Subject: **Bid No. 8819-M7 – Sprinkler & Fire Alarm Modifications – Union Station / WRA**

ADDENDUM NO. 3

SPRINKLER AND FIRE ALARM
MODIFICATIONS PHASE 2
UNION STATION
WORCESTER, MA

M001

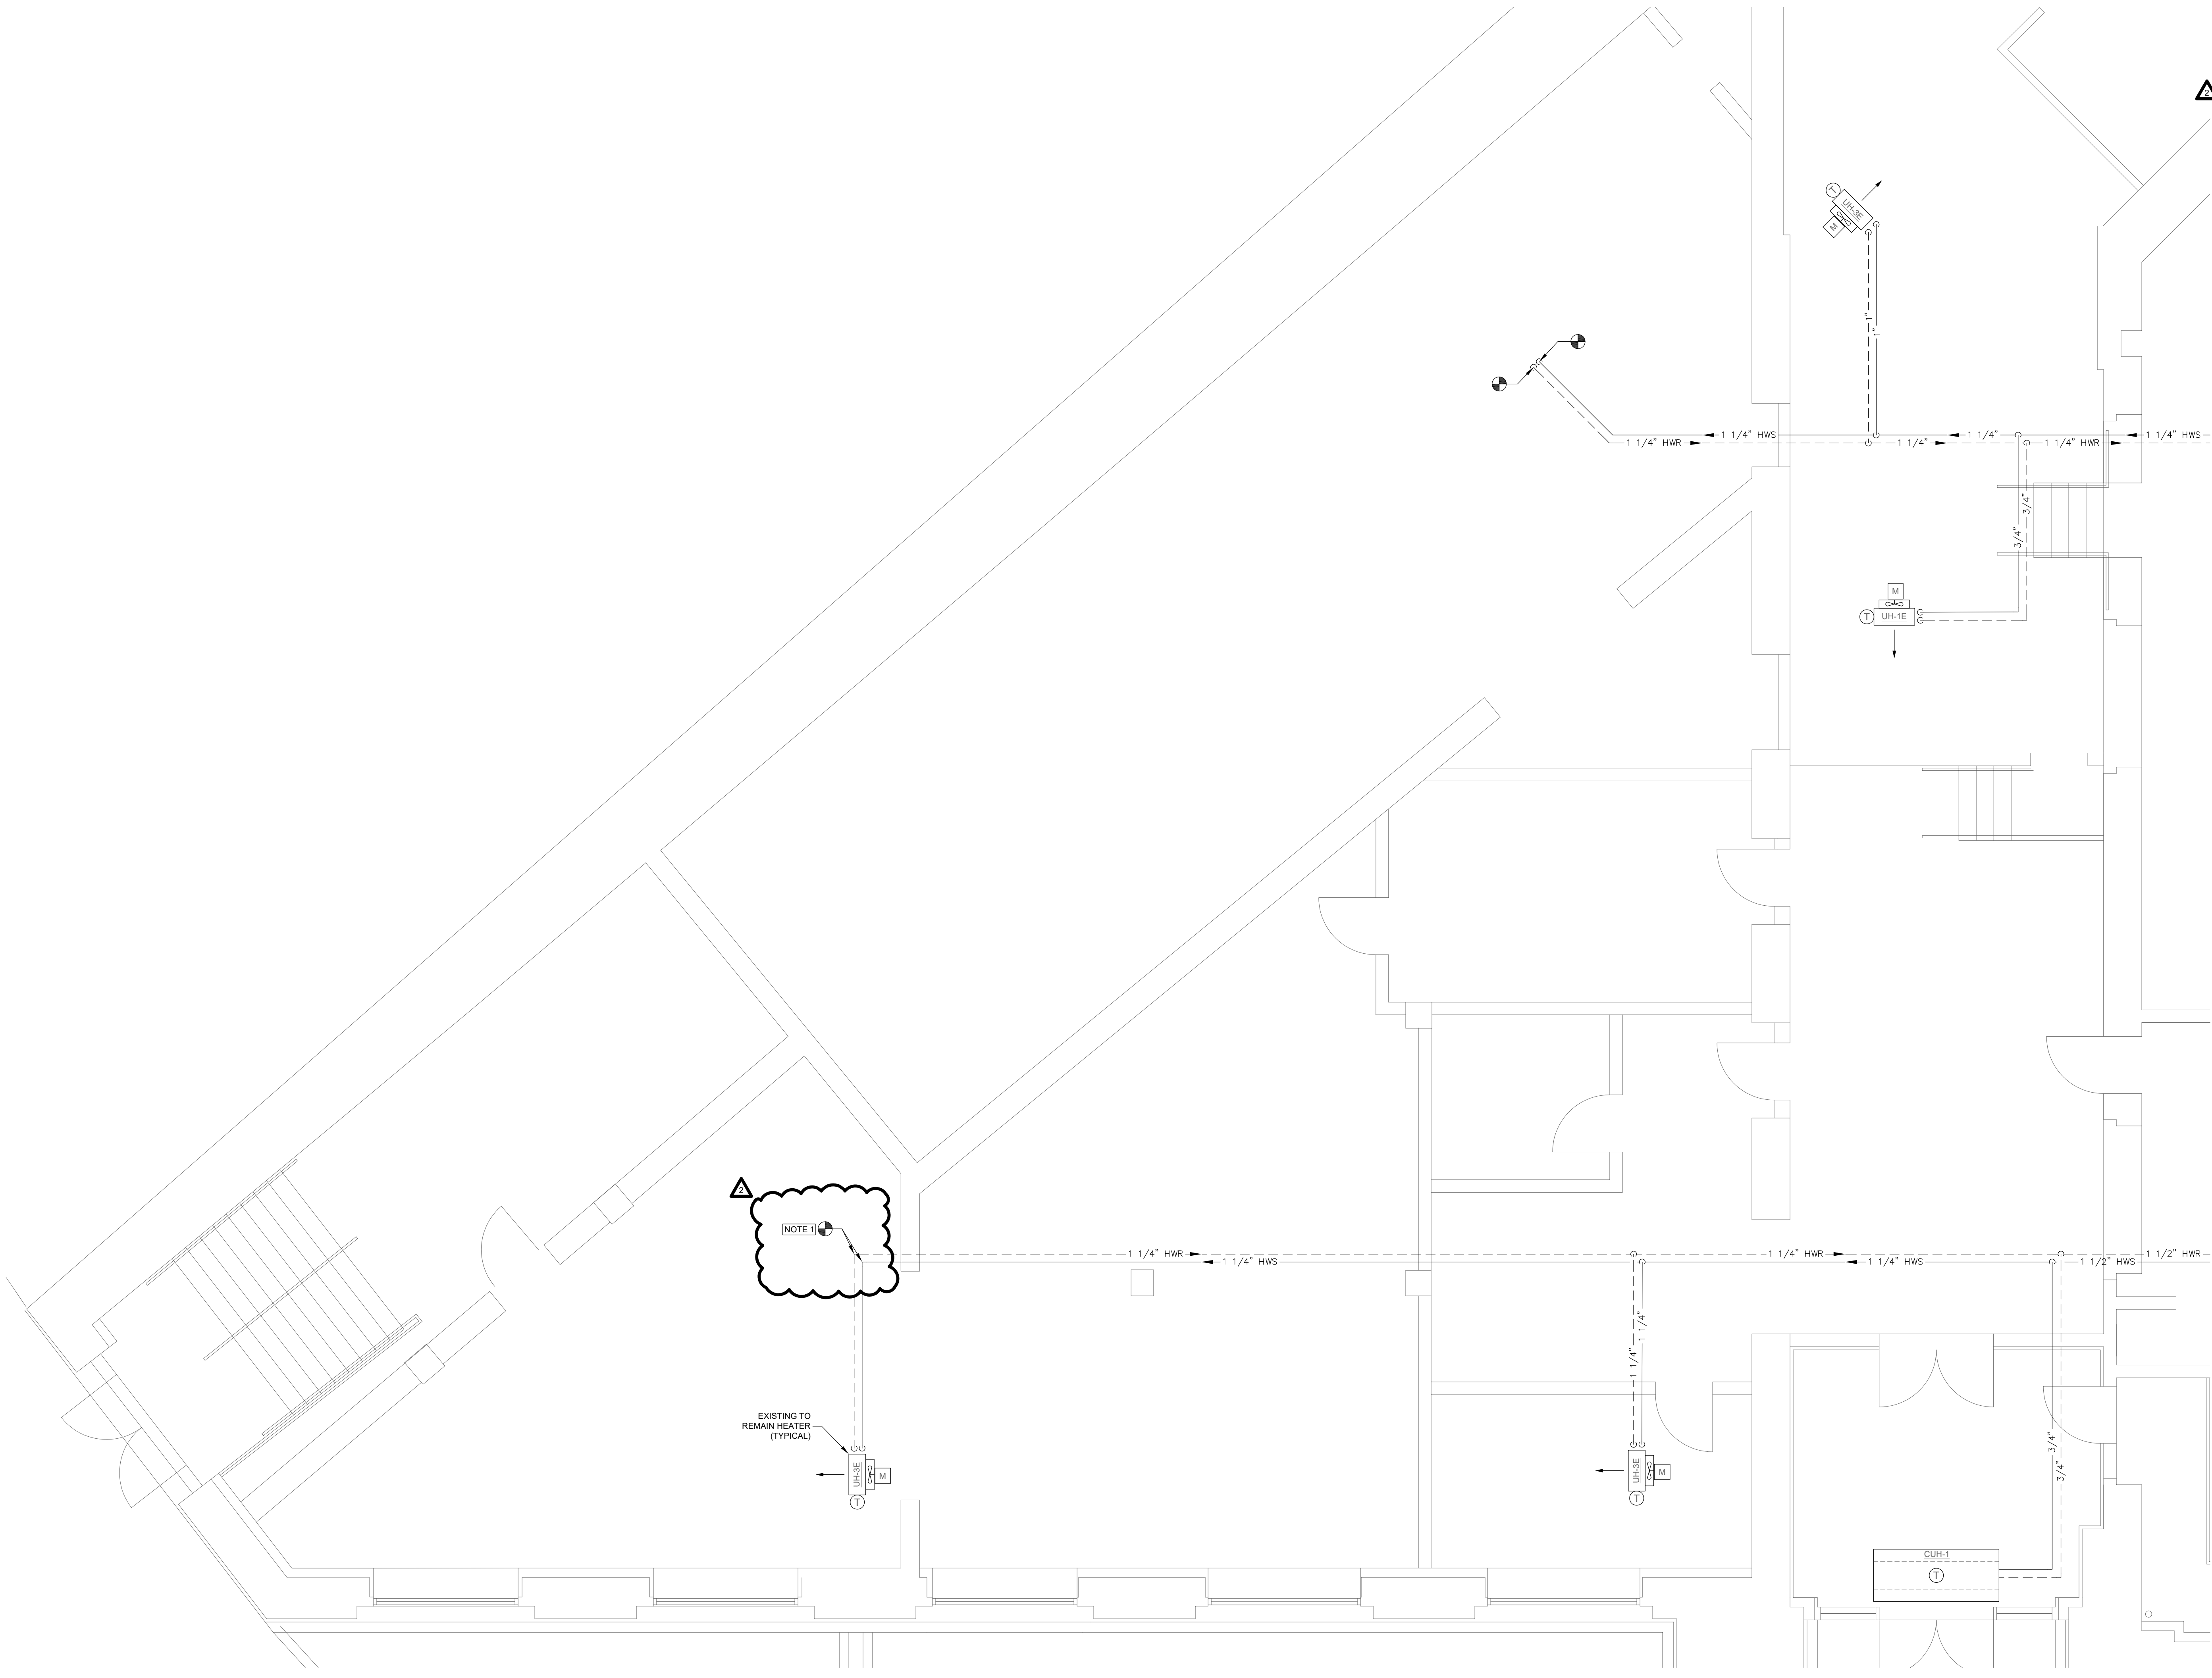
Drawing M001, Mechanical Legend and Abbreviations, Revise as follows:

- ADD leak detector to legend.

MD102

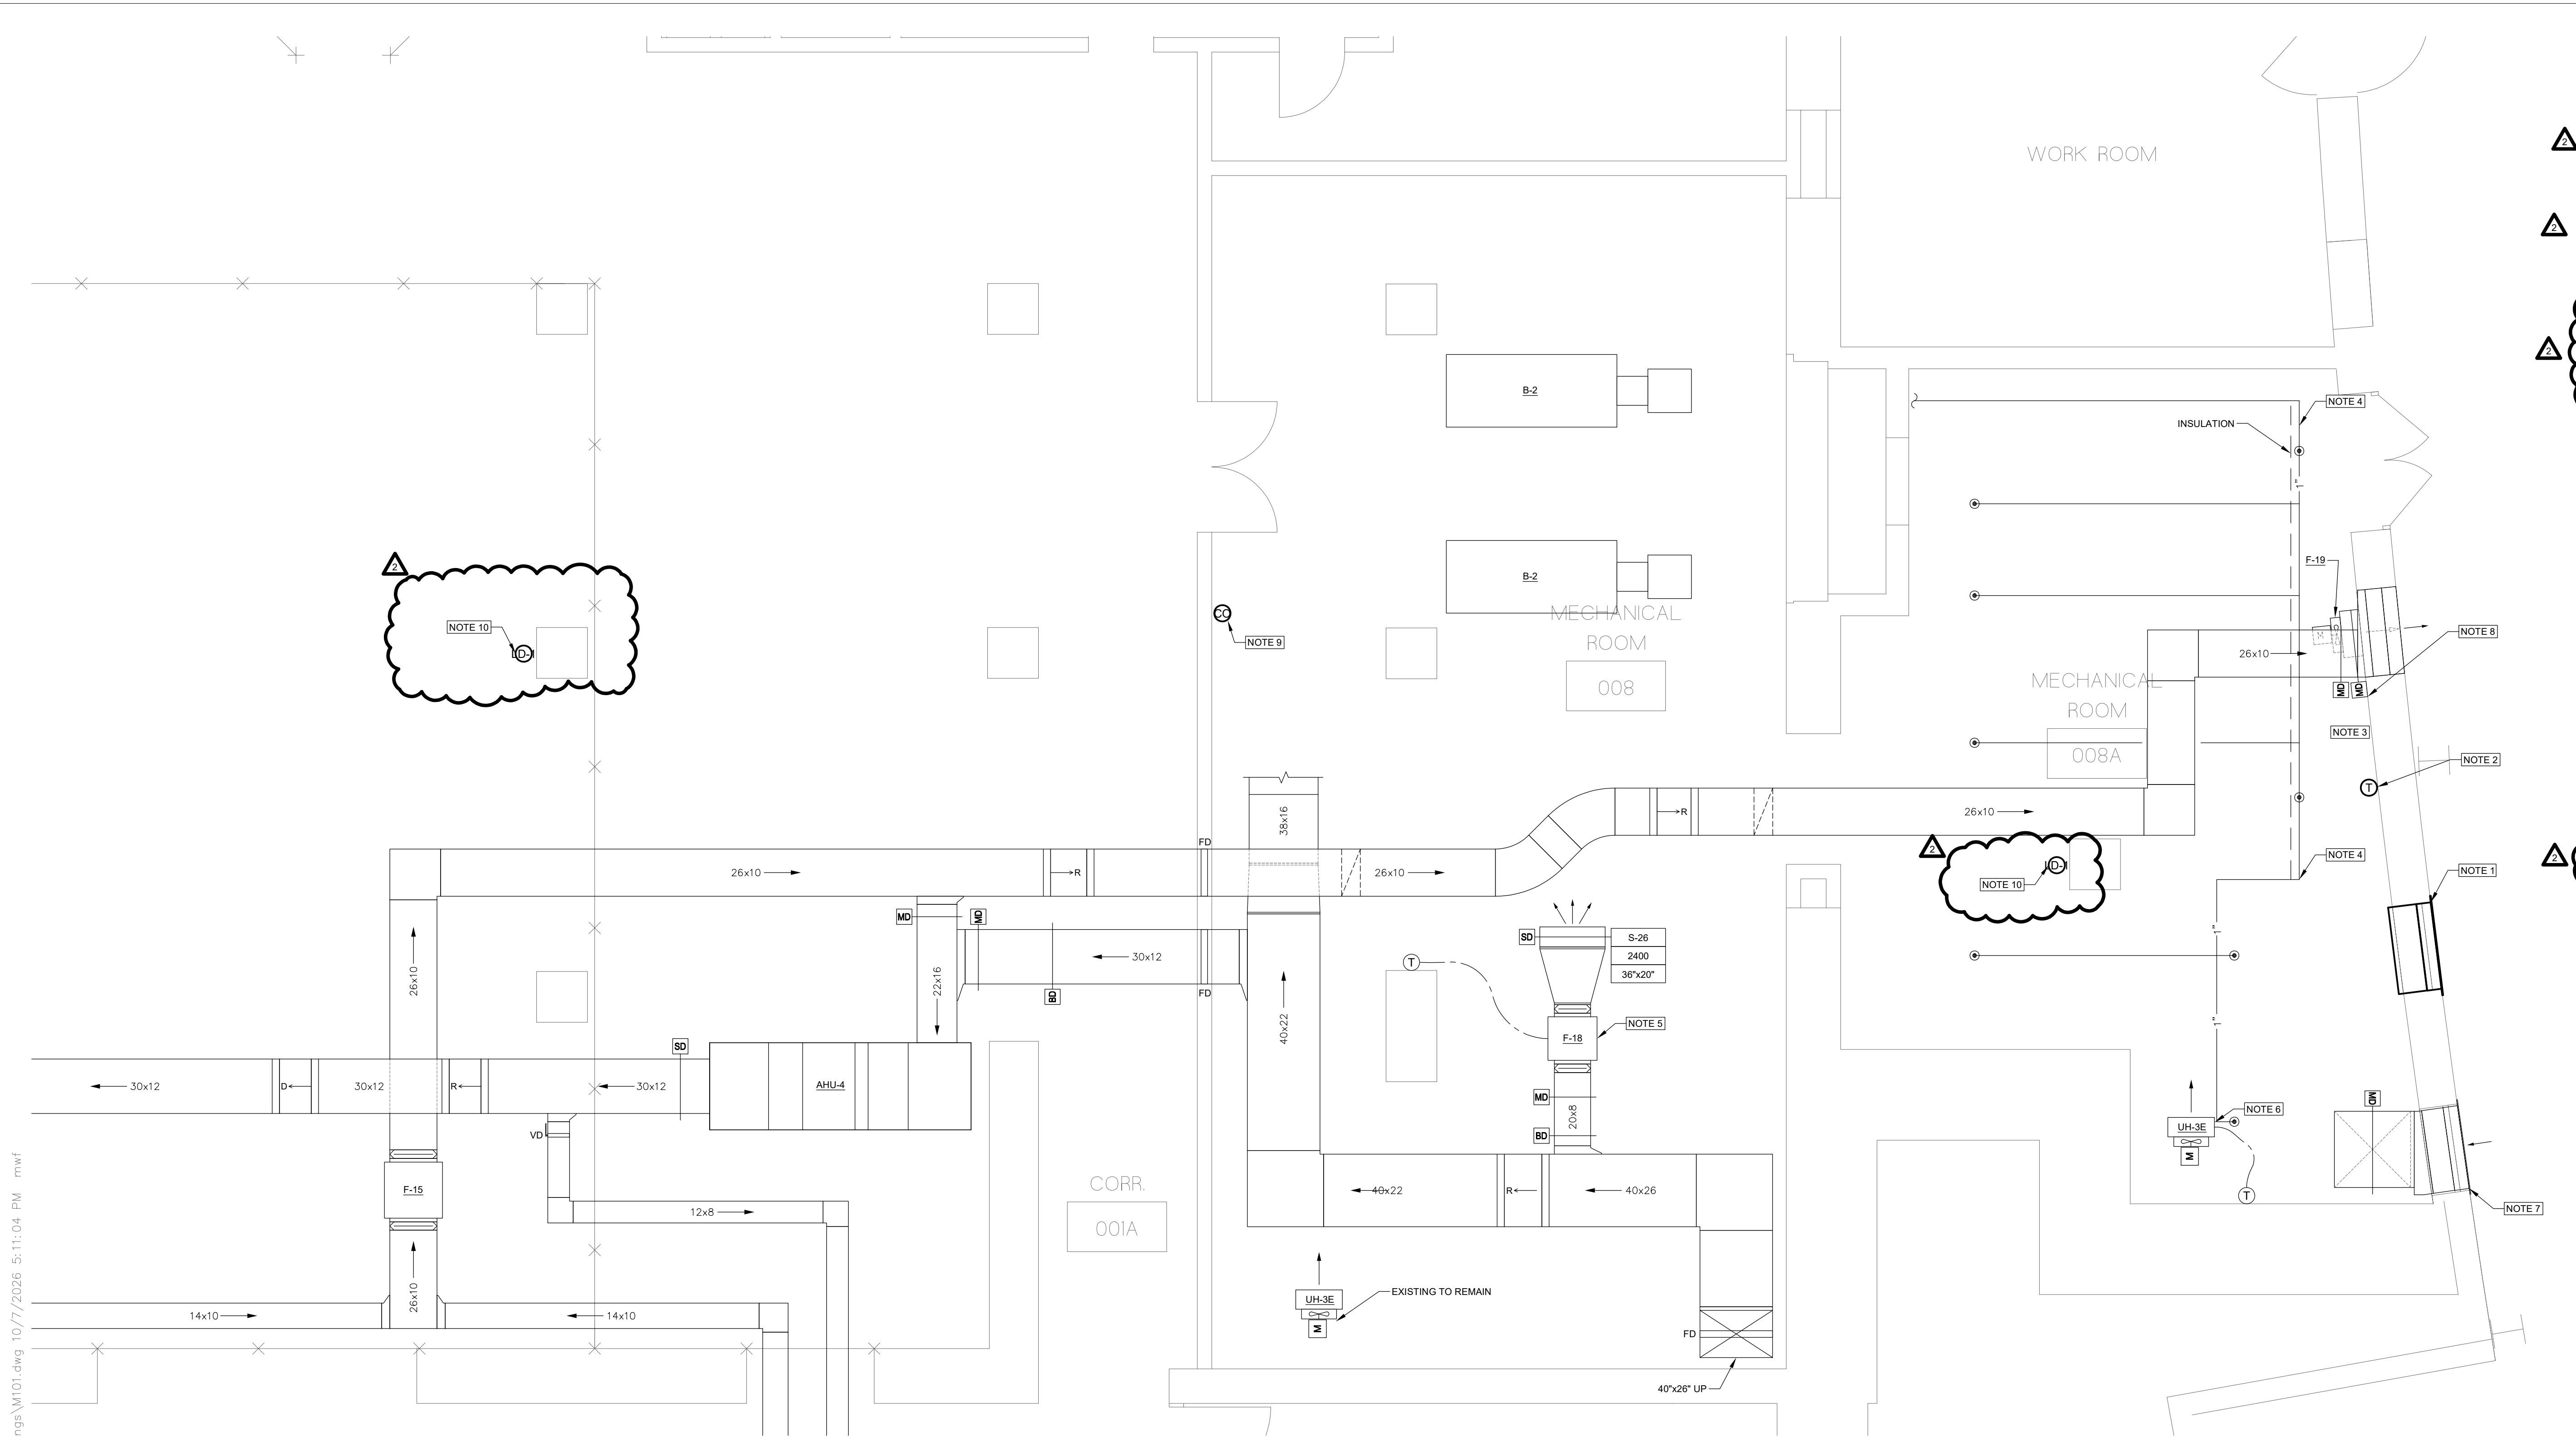
Drawing MD102, Mechanical First Floor Demolition Plan, Revise as follows:

- ADD point of deactivation and associated Keyed Note 1.

M-601

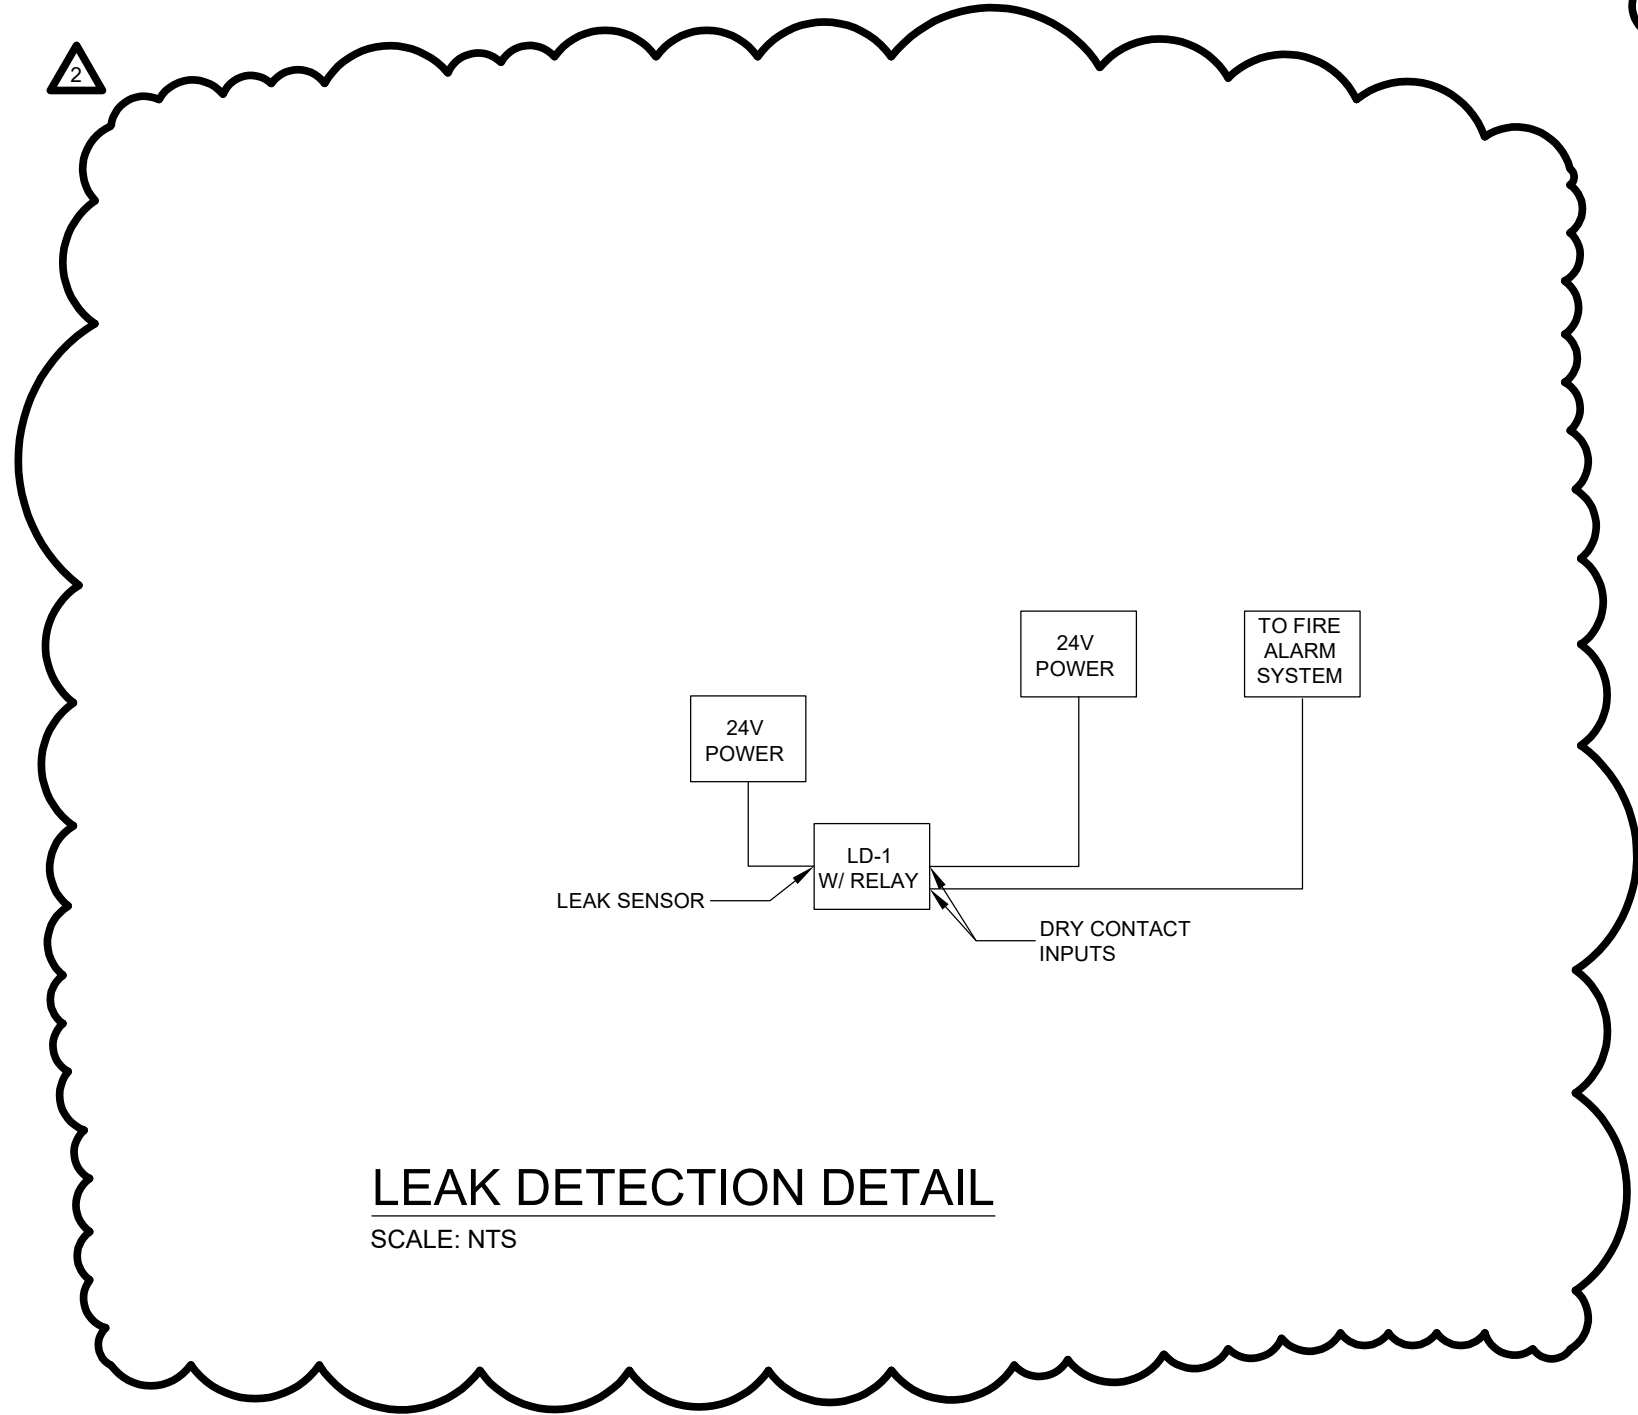
Drawing M601, Mechanical Schedules, Revise as follows:

- ADD sensor schedule.
- ADD Leak Detection Detail.
- ADD Drawing E100, Electrical Power Partial Basement New Work Plan, adding junction boxes to provide power for leak detection controllers.
